Delegated Report	Analysis sheet	Expiry Date:	19/01/2022
	N/A	Consultation Expiry Date:	26/12/2021
Officer		Application Number(s)	
Sofie Fieldsend		2021/4294/P	
Application Address		Drawing Numbers	
18 Greville Street London EC1N 8SQ		See draft decision	
Proposal(s)			
Erection of a 5 storey rear extension and a roof extension with front dormer to create additional jewellery workshop space.			
Recommendation(s):	Refusal		
	Full Application

Image 1: First floor layout as shown in certificate granted at 17 Greville Street ref. 2021/1162/P

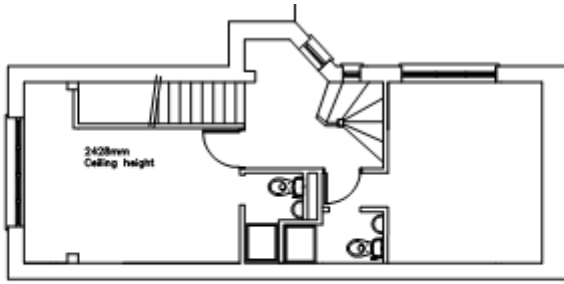
flats which are only served by this one window. The floor plans for this recent application also show a large side window at first floor (Image 1) which is the only window serving this flat.

site, which have all been assessed for daylight impacts. The habitable room at 1st floor has not been assessed and, given the layout indicated above, it should be included for a full assessment. The remaining smaller side windows in the corner of the lightwell serve the stairwell which is a non-habitable space, as shown on Image 1 above. The report has only tested VSC values which show that 80% is retained for all three windows at 2nd - 4th floors - this complies with BRE guidelines. However the 1st floor side window has not been tested. It was noted in para 5.2 above that this side window at first floor is the only window serving this studio flat.

Image 2: Aerial view showing the tight grain with neighbouring properties

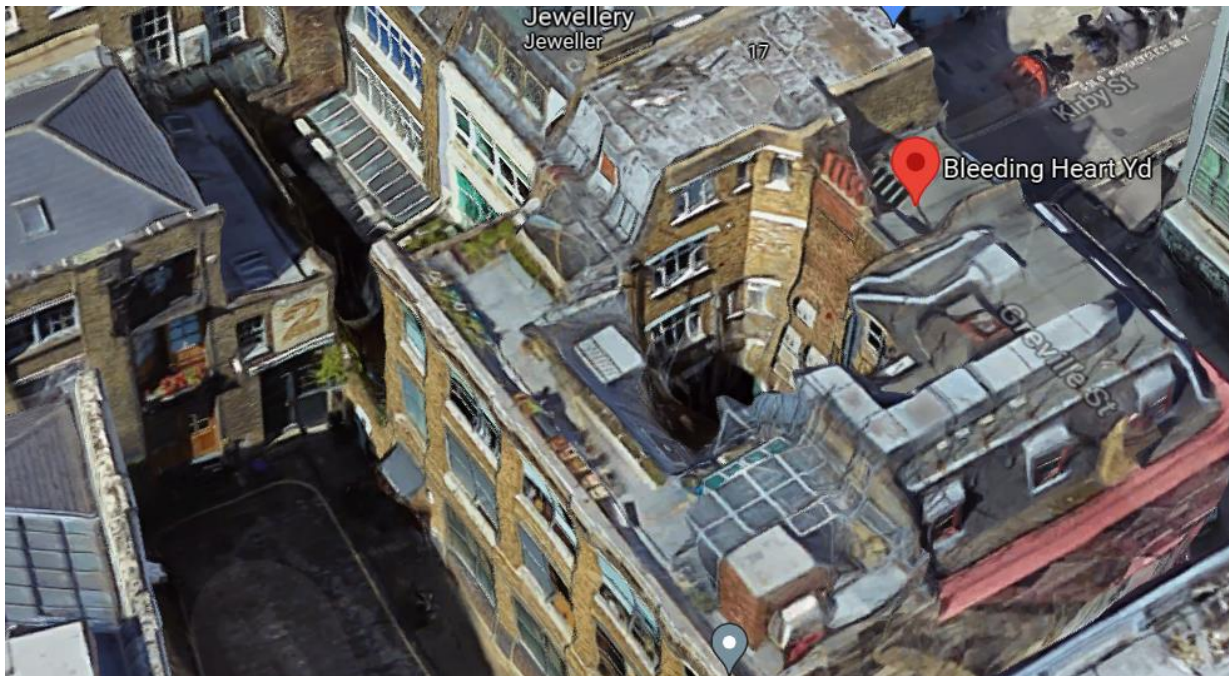
3.9 It is noted that the rear courtyard is entirely enclosed by neighbouring properties and this site has a tight urban grain.

- 5.2 It is acknowledged that the rear of the site is tightly constrained with the neighbouring buildings to the east and west on Greville Street and to the south on Bleeding Heart Yard. West of the application is No.17 Greville Street which is in residential use, containing 8 flats across the 1st - 4th floors with windows on the flank elevation facing onto the rear of No.18. A recent Certificate of Lawfulness ref. 2021/1162/P granted on this property confirms the layout and shows that, while the two smaller windows within the rear corner serve the staircase at all upper floor levels, the larger side window on each floor facing the lightwell does serve habitable rooms. At fifth floor the larger side window serves a bedroom and at fourth floor a kitchen/dining room. It is noted that the rooms at 1st - 3rd floors are individual
